Insufficient car parking provision

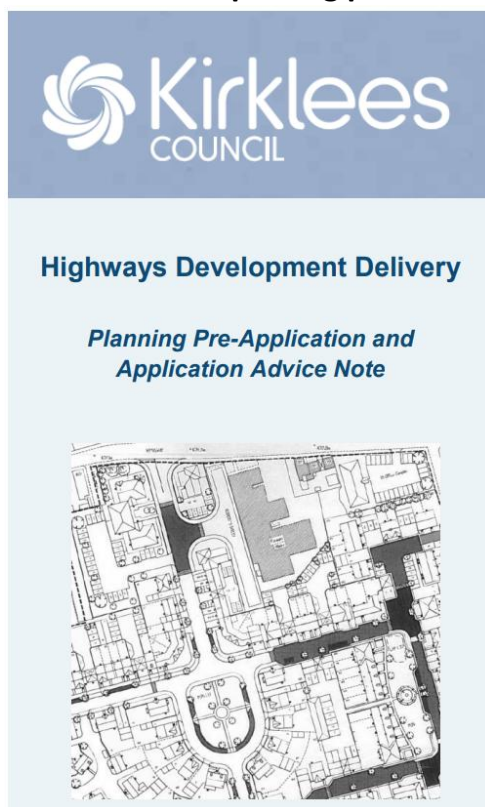
Looking at the application, I do not believe it satisfies this requirement.

Take the 9 dwellings proposed, adjacent to Lingards Road, they are shown to have 3 car parking spaces each, which is the minimum required.

Rounding up the additional requirement, there should be provision for 3 more spaces.

To be practical, those spaces should be available close to the dwellings they would serve.

No such spaces are allowed for.

Without provision for these additional spaces, the application fails to satisfy even the minimum requirements.
